1208 OLIVE

DESIGN RECOMMENDATION MEETING

1208 E. Olive, Seattle, WA 98122

EDG Report Responses

COURTYARD LANDSCAPE PLAN

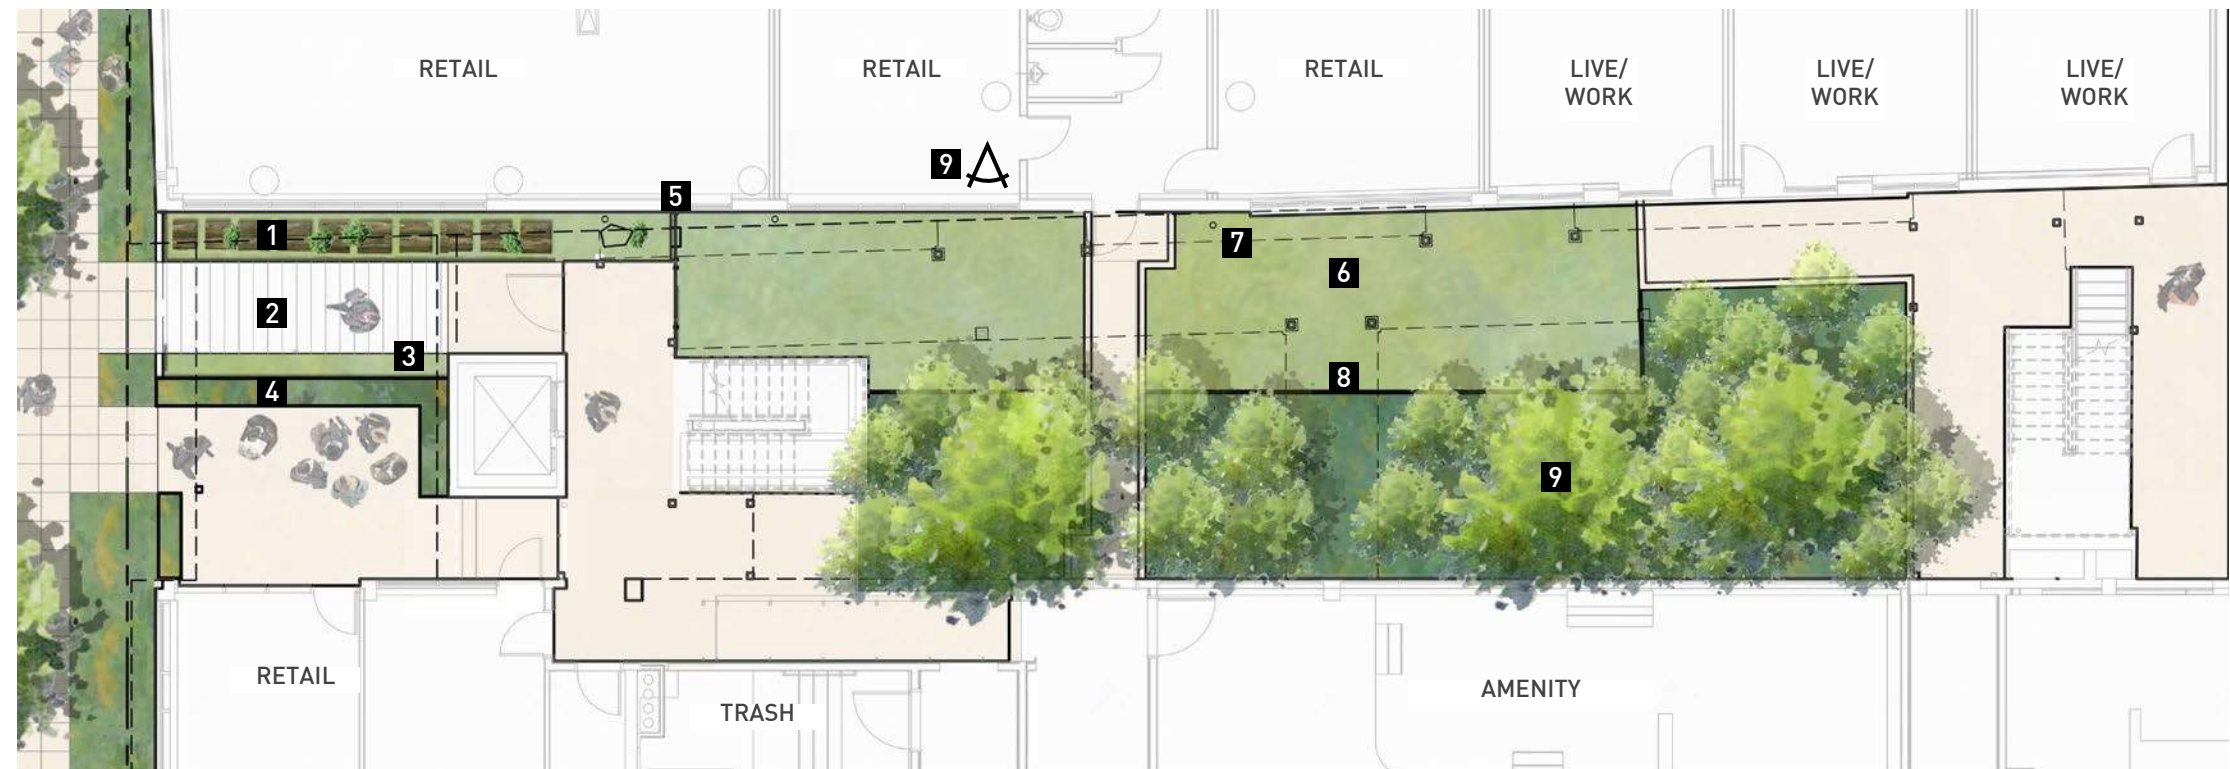
- d) The Board supported the use of evergreen trees in the courtyard as indicated in the model shown at the EDG meeting, but recommended careful consideration in the section of landscaping, as larger trees may need to be removed or replaces in the future.

- d) While the model indicated evergreen trees, the model was meant to convey a more conceptual experience of the courtyard. The design team has given further thought to the planting material at the courtyard and are proposing more deciduous plant selections in conjunction with what might be found at the typical northwest understory and forest floor to allow the most light to penetrate into the lowest levels of the courtyard. Please refer to the landscape plans in the DRB Packet.

PERSPECTIVE SECTION THROUGH OLIVE ENTRY + COURTYARD (EAST-WEST SECTION)

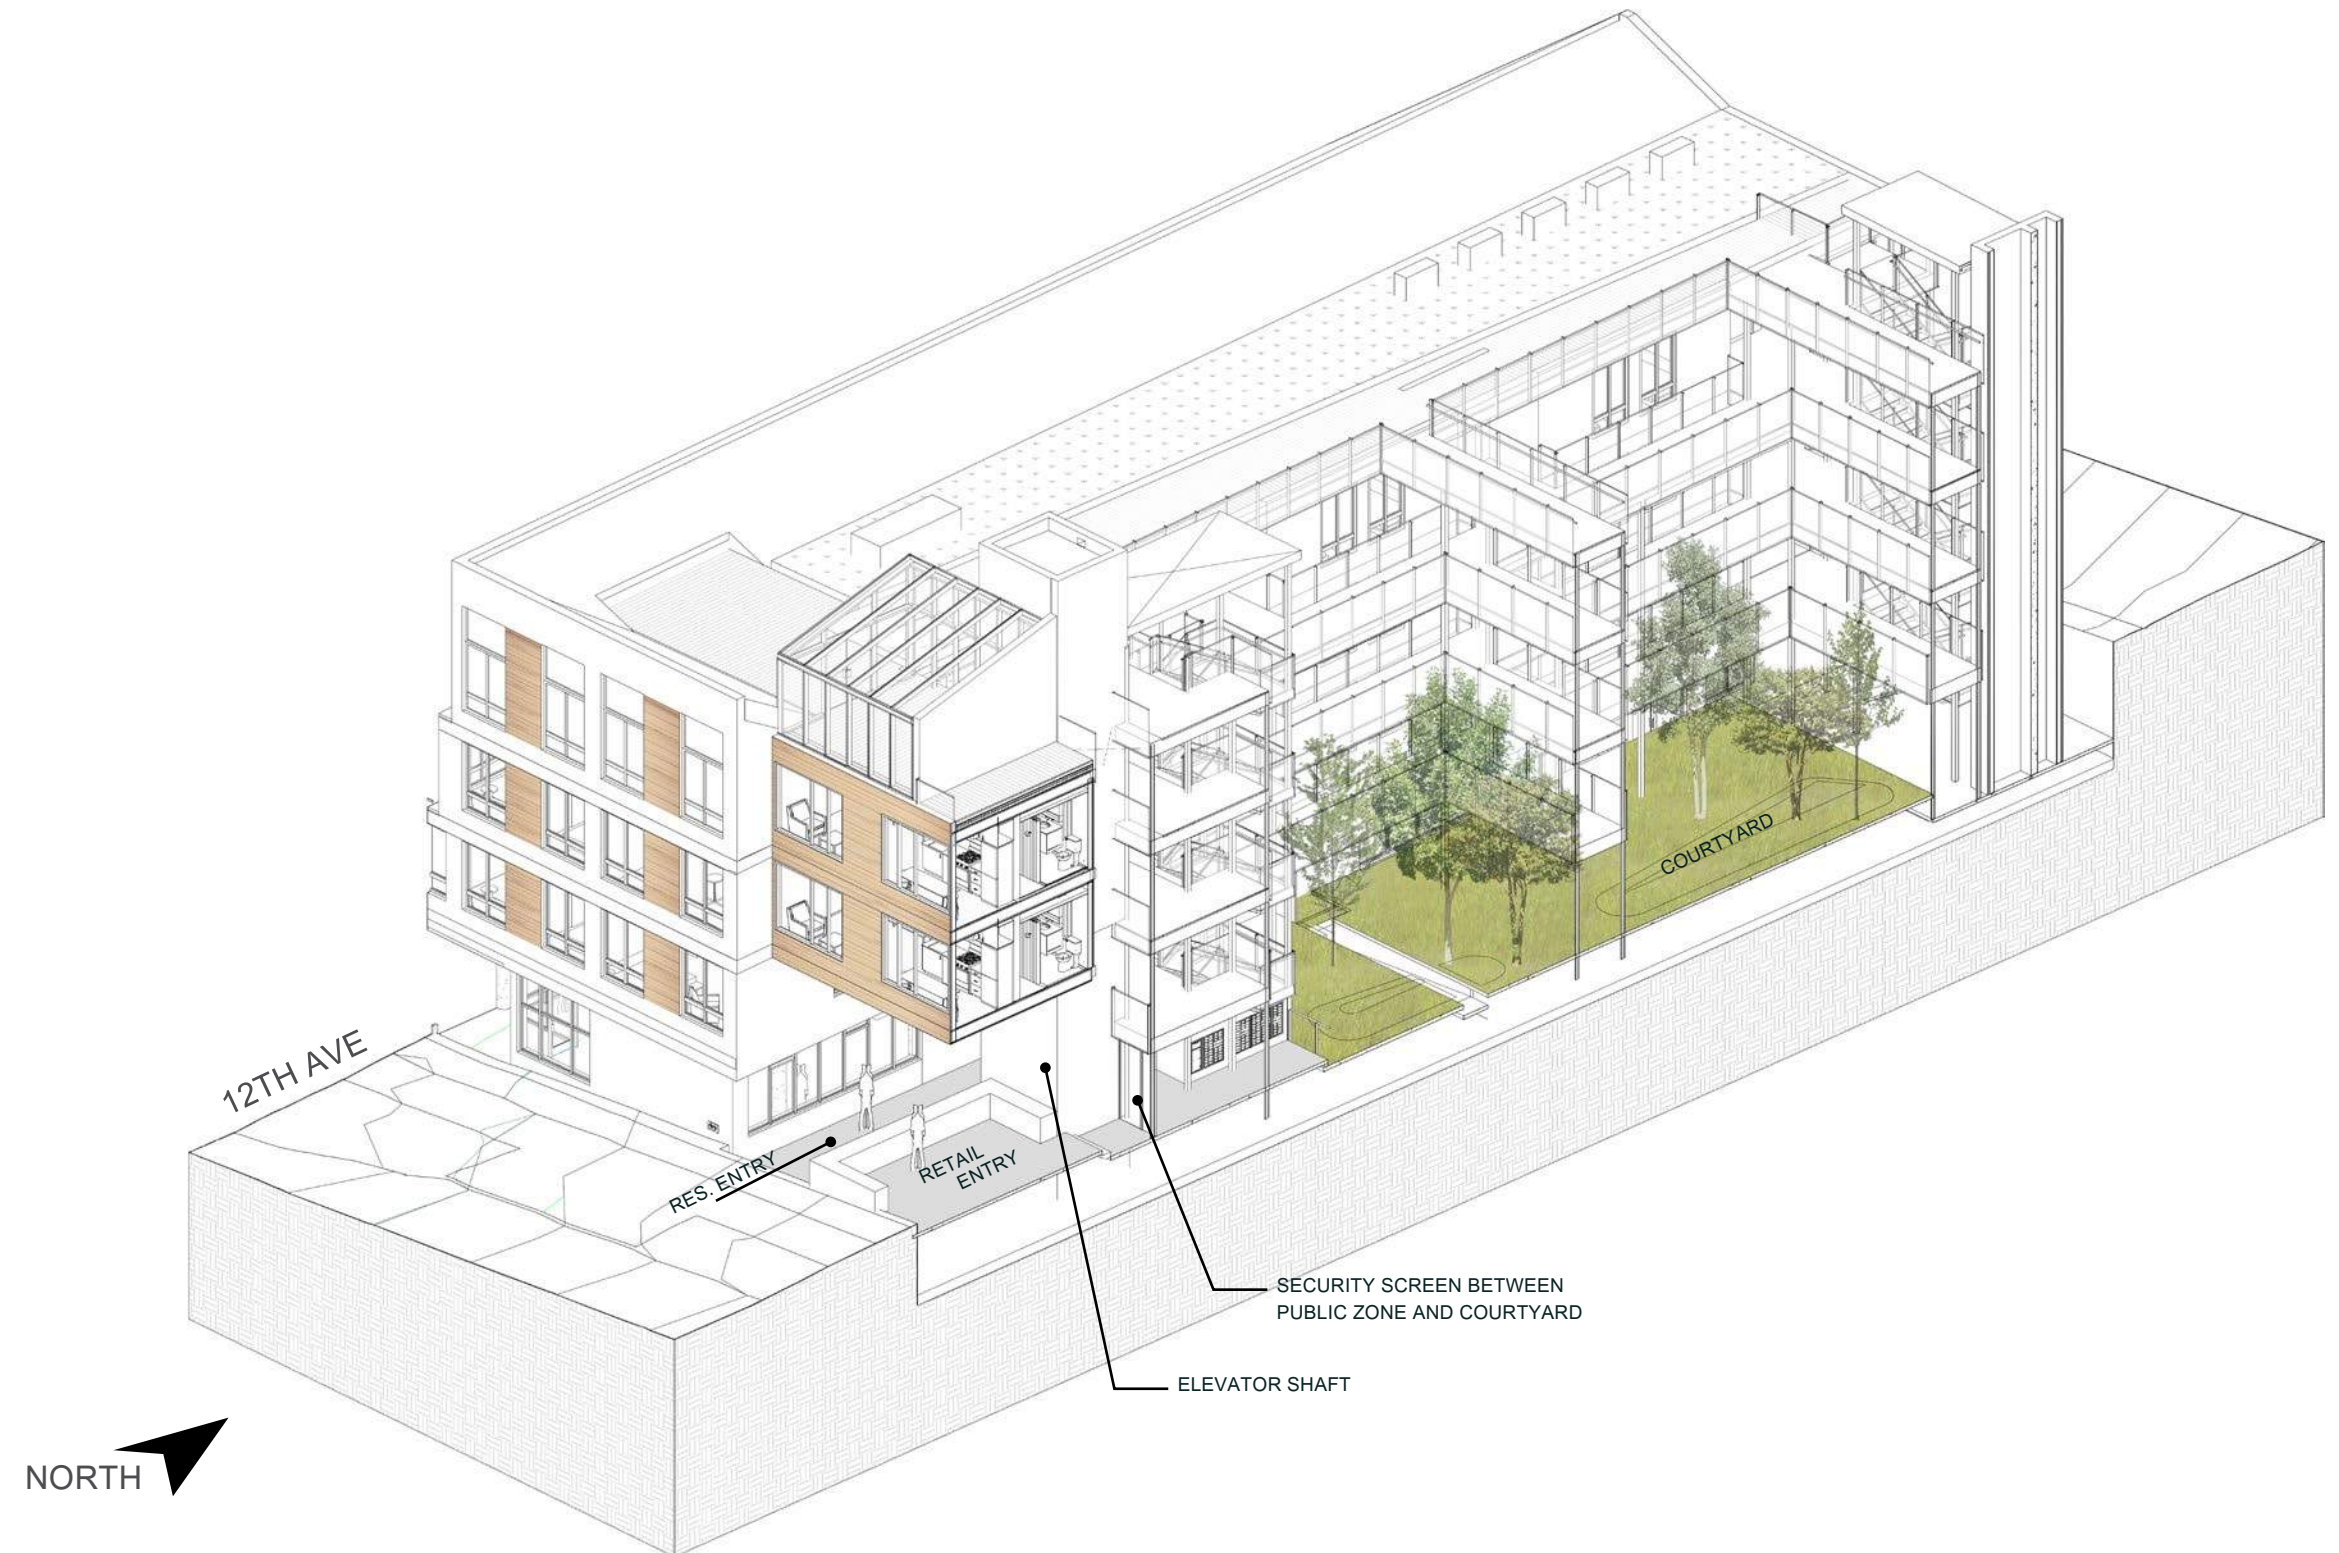
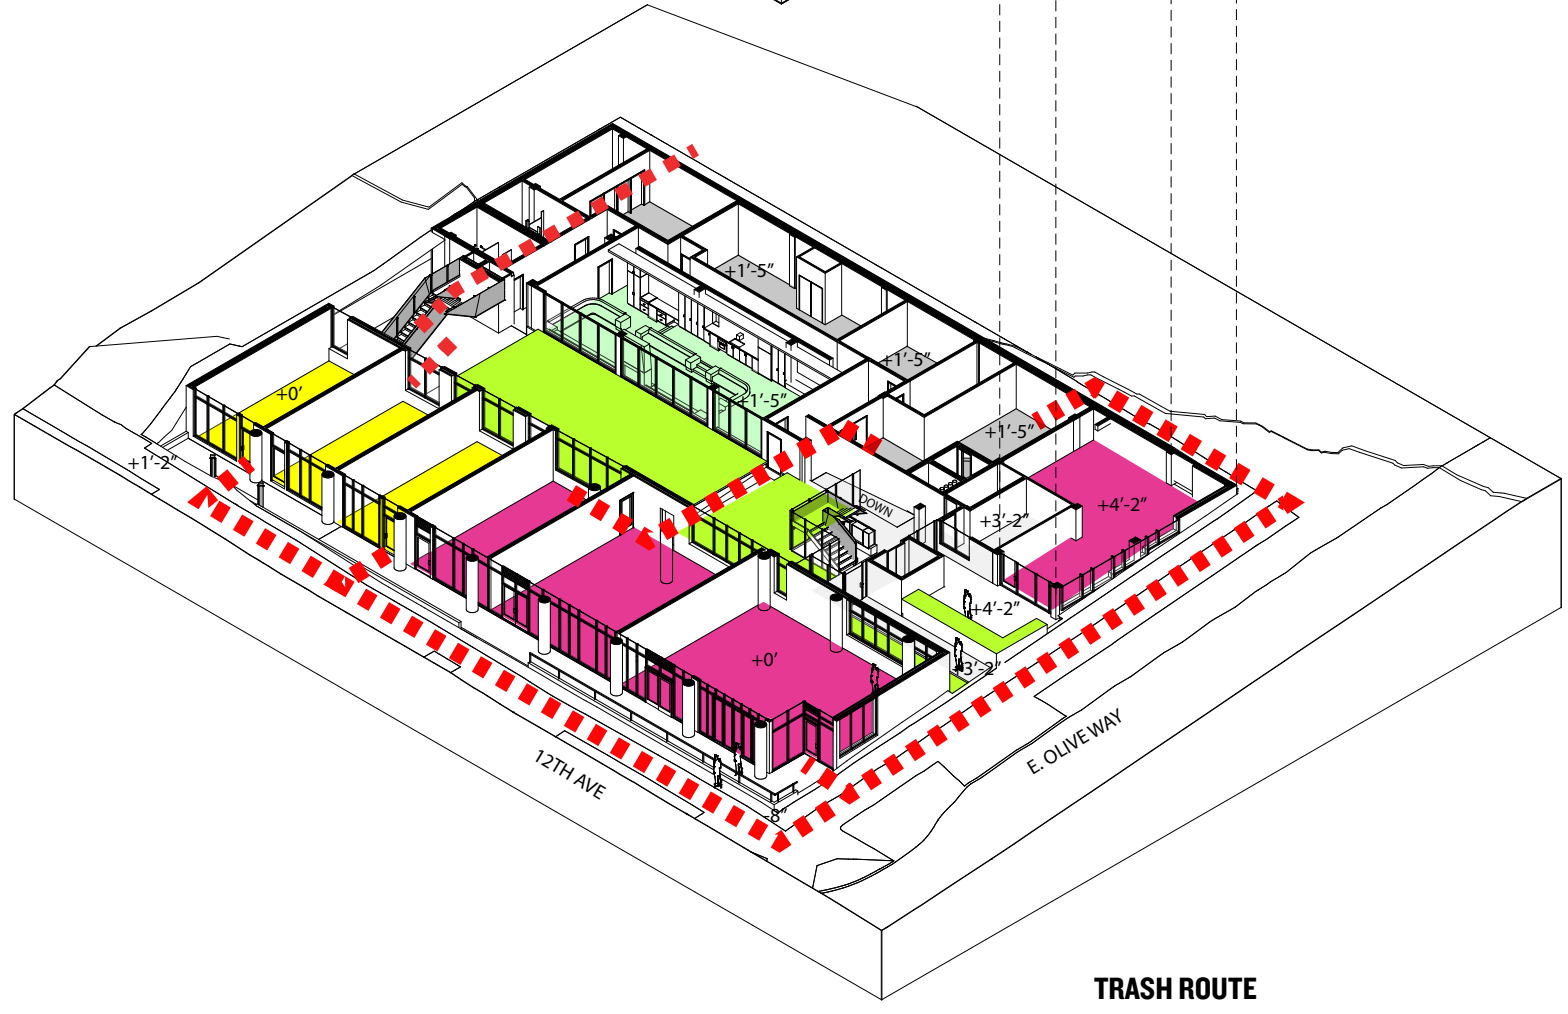
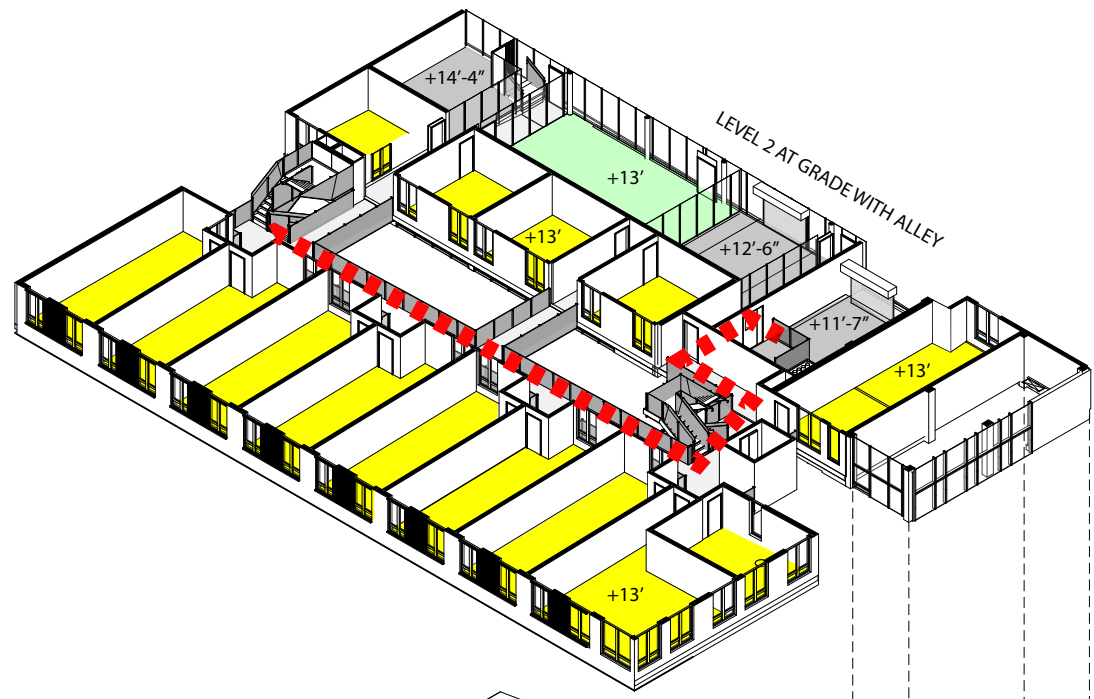
- a) The Board expressed enthusiastic support for the “urban forest” courtyard concept.
- b) The Board stressed the importance of creating a strong visual connection to the courtyard from the sidewalk, particularly from 12th Ave, as depicted in the packet and model shown at the EDG meeting. The transparency of the commercial spaces and maintaining the elevation of the courtyard at or very near the elevation of the sidewalk is necessary to establish a visual connection from 12th Ave. The Board requested section drawings depicting the relationship of the sidewalk to the courtyard to be provided at the next meeting.

- b) The Board supported the location of the residential entry on E. Olive Street, but struggled to understand the relationship of the entry and sidewalk to the lobby and courtyard. The Board requested section drawings illustrating this relationship be provided at the next meeting.

- a) The project is maintaining the “urban forest” concept. Please refer to the sections and perspectives in the DRB packet.
- b) Please refer to section drawings in the DRB Packet pertaining to the relationship between 12th Ave and the courtyard.

- b) The residential entry has remained in the same location as was presented in the EDG meeting but has been further refined to include a bridge element over a raingarden and a subtle water feature to mask street noise, all in an effort to make the entry experience a tranquil transition from busy city life into the courtyard garden. Please refer to section drawings in the DRB packet pertaining to the residential entry relationship to the courtyard and street.

TRASH CIRCULATION PATHS

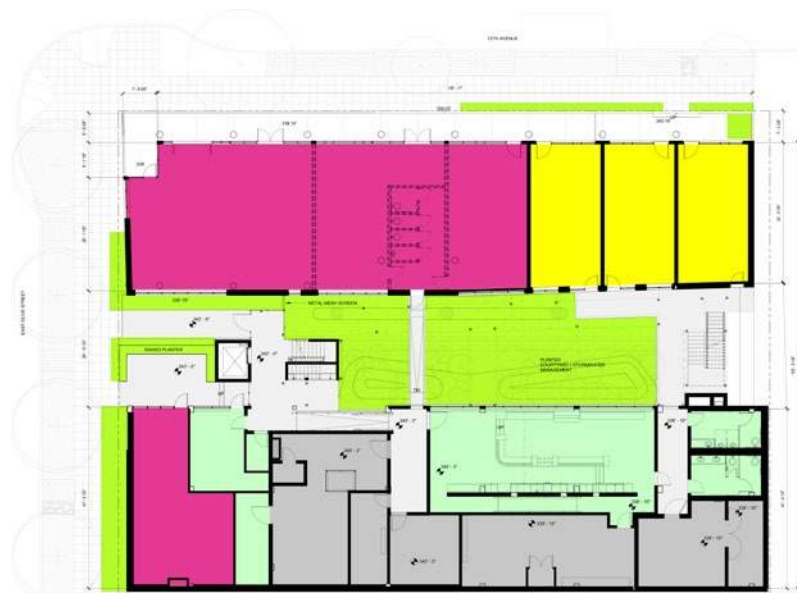
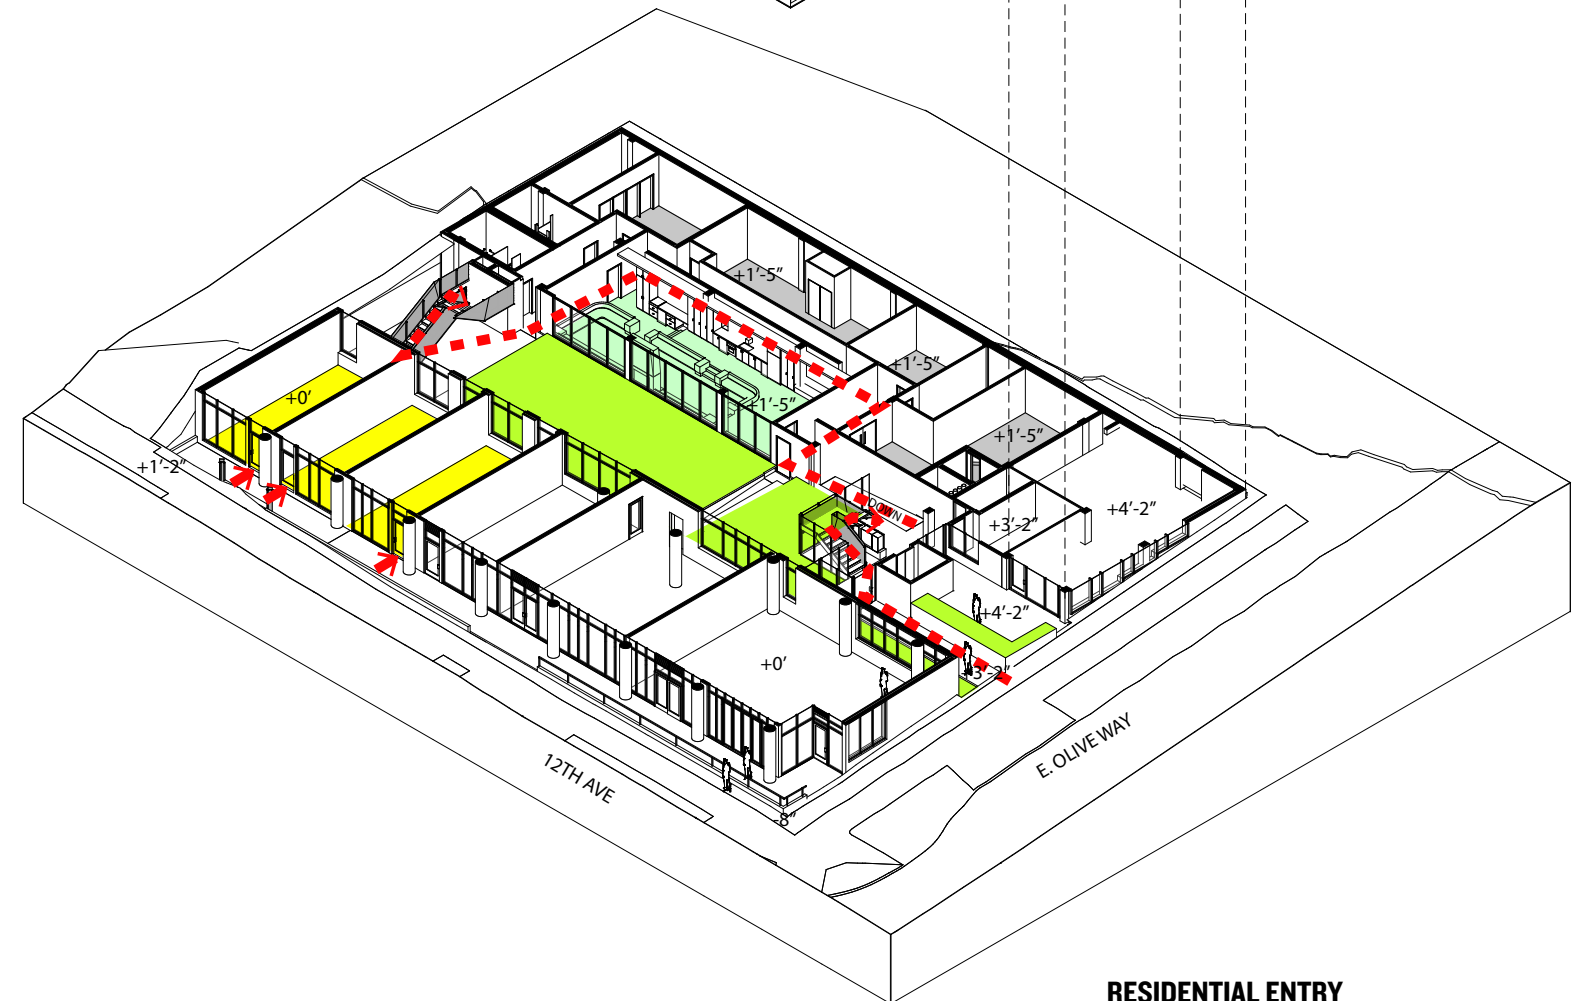
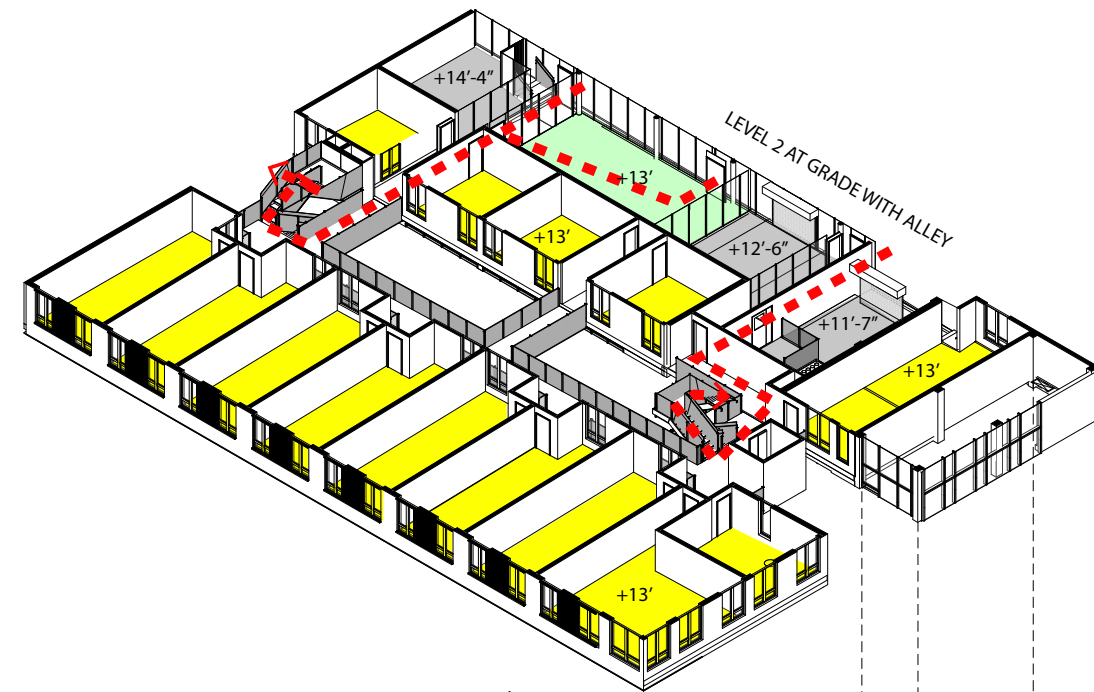
- c) The Board expressed concern with the conflict between the bike parking access and outdoor café seating area. The Board was also concerned with the lack of interior access to trash and recycle to commercial tenants. A circulation diagram should be provided at the next meeting demonstrating resolution of these conflicts.

- c) The bike parking has been revised and is no longer accessed via the seating area outside the commercial space on Olive Way but rather is accessible via the alley. Please refer to the Trash Circulation Diagram in the DRB Packet that addresses a clear route of how trash is dealt with from retail/commercial spaces via an interior access route.
